SERVICE BULLETIN

Classification: EM87-010	Reference: TS87-191	Date: December 28, 1987
-----------------------------	------------------------	----------------------------

VG30 ENGINE MODIFICATIONS

APPLIED VEHICLE(S): All vehicles with VG30 Engine

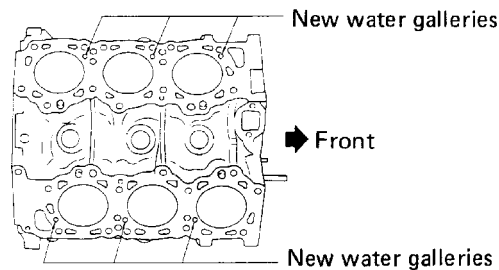
The MODIFIED AND NON-MODIFIED engines can be identified by the engine serial number as follows:

MODIFIED	NON-MODIFIED
(XXXXXX W)	(XXXXXX A) OR (XXXXXX B)

Component Name: Cylinder Block

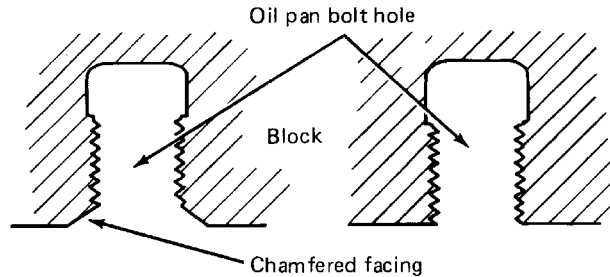
SUMMARY OF CHANGES: Six new water galleries were added at the exhaust side of the cylinders.

NOTE: The "W" engine bare block will NOT be stamped with a "W". Check for additional water galleries to identify a modified bare block.

SUMMARY OF CHANGES: In addition, the oil pan bolt holes have been altered in the modified cylinder block. The holes have been chamfered to allow usage of a liquid oil pan gasket. These chamfered bolt holes are also helpful in identifying the modified bare block.

Component Name: Piston & Piston Pins

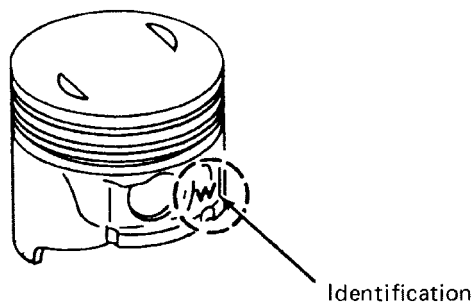
SUMMARY OF CHANGES: The piston and pin have been changed to a full-floating type, with two snap rings to locate the piston pin outer diameter has been decreased.

The modified piston can be identified by a “W” mark on the piston skirt (As shown).

NOTE: A “W” piston requires a modified connecting rod, wrist pin, and piston rings.

Component Name: Connecting Rod

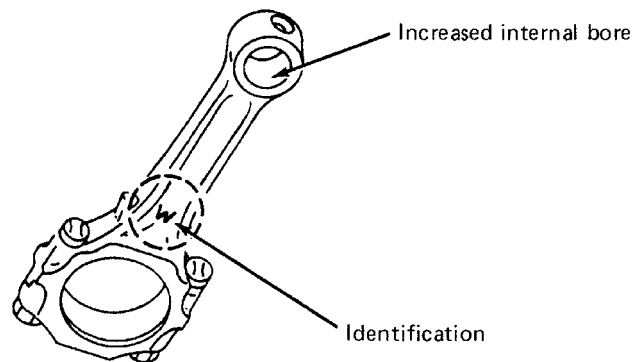
SUMMARY OF CHANGES: The modified connecting rod has been increased in weight, along with an increase in small end internal bore. It can be identified by a “W” stamped in the side of the rod shaft as shown in illustration.

NOTE: A “W” connecting rod requires a “W” piston, new style wrist pin, and modified crankshaft.

Component Name: Crankshaft, Pulley, Bolt & Washer

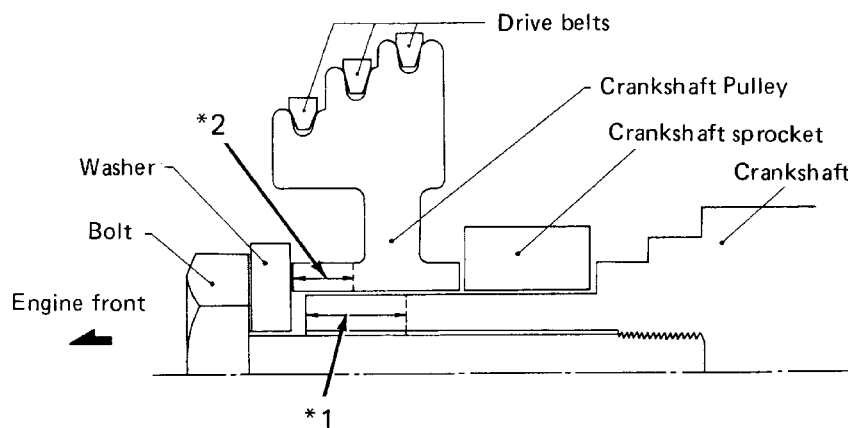
SUMMARY OF CHANGES: The crankshaft front tip was lengthened by 18.7mm (0.736 in). See illustration (*1).

The crankshaft pulley width was increased by 13.6mm (0.535 in.) as shown (*2).

The pulley bolt was changed from M12 to M14, and the washer inner and outer diameter were increased. (See illustration.)

Component Name: Cylinder Head

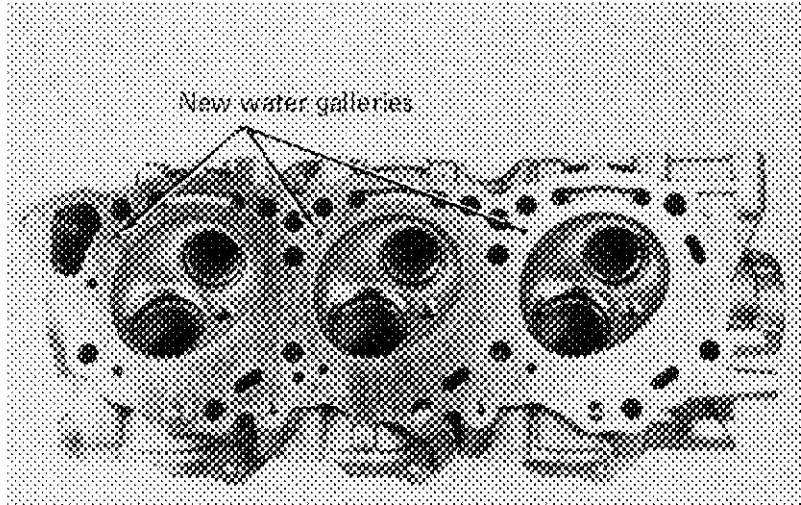
SUMMARY OF CHANGES: Three new water galleries were added to each cylinder head (at the exhaust side). These match the new galleries in the block.

Component Name: Cylinder Head Gasket

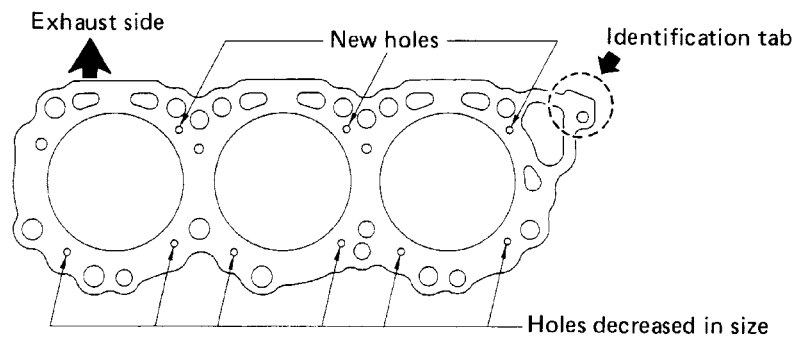
SUMMARY OF CHANGES: Three new holes were added to the gasket on the exhaust side, and the six holes in the intake side of the gasket were decreased in size.
